World Forum for Harmonization of Vehicle Regulations

Working Party on General Safety Provisions

Proposal for Amendment 2 to UN Global Technical Regulation No. 6 (Safety glazing)

Submitted by the expert from the Republic of Korea*

Figure 4
Determination of Zone I

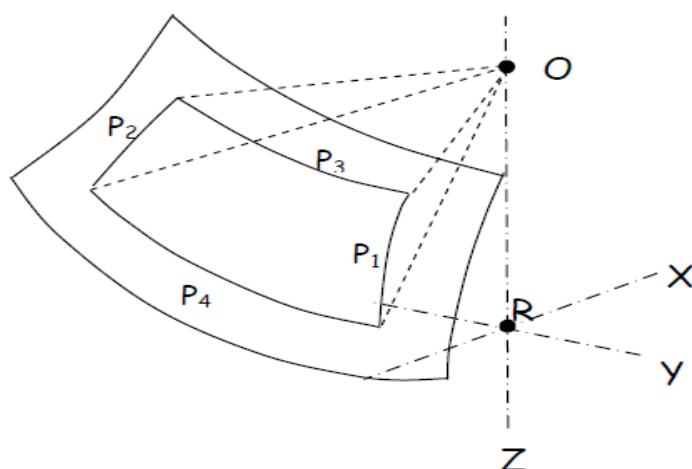
In addition, opaque obscuration can be exempted in Zone I. It is the limited areas where it is intended that a sensing device, e.g. a rain-drop detector, rear view mirror or autonomous sensors, will be bonded to the inner side of the windscreens. The opaque obscuration where such devices may be applied is defined in paragraph 7.1.3.2.4. of this annex.

P1 a vertical plane passing through 0 and forming an angle of 15° to the left of the median longitudinal plane of the vehicle;

P2 a vertical plane symmetrical to P1 about the median longitudinal plane of the vehicle.

If this is not possible (in the absence of a symmetrical median longitudinal plane, for instance) P2 shall be the plane symmetrical to P1 about the longitudinal plane of the vehicle passing through point O.

P3 a plane passing through a transverse horizontal line containing O and forming an angle of 10° above the horizontal plane;

P4 a plane passing through a transverse horizontal line containing O and forming an angle of 8° below the horizontal plane;

Figure 4(a)

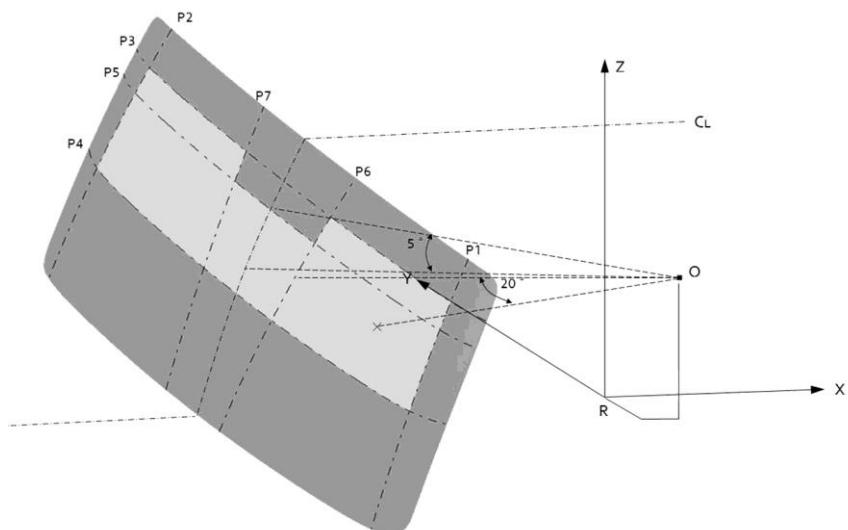
7.1.3.3.3.1. At the discretion of the vehicle manufacturer, one of the two following paragraphs may apply: (See Figure 4(a) or Figure 4(b))

7.1.3.3.3.1.1. Any opaque obscuration bounded downwards by P5 and laterally by P6 and P7;

Zone I (example of a left-hand steering control vehicle)

(Upper obscuration area as defined in paragraph 7.1.3.3.3.1.1.)

Figure 4(b)

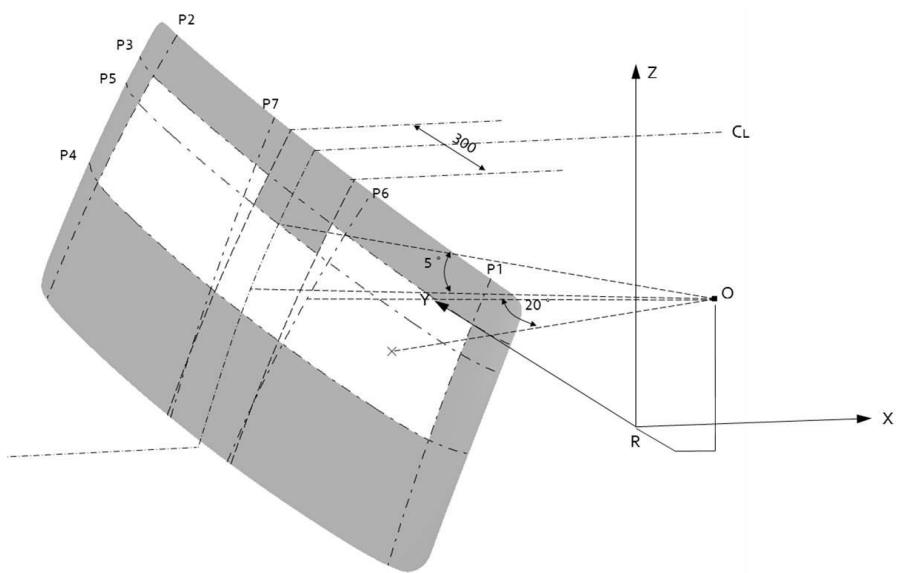
7.1.3.3.3.1.2. Any opaque obscuration bounded downwards by P5, provided it is inscribed in an area 300 mm wide centred on the longitudinal median plane of the vehicle.

Zone I (example of a left-hand steering control vehicle)

(Upper obscuration area as defined in paragraph 7.1.3.3.3.1.2.)
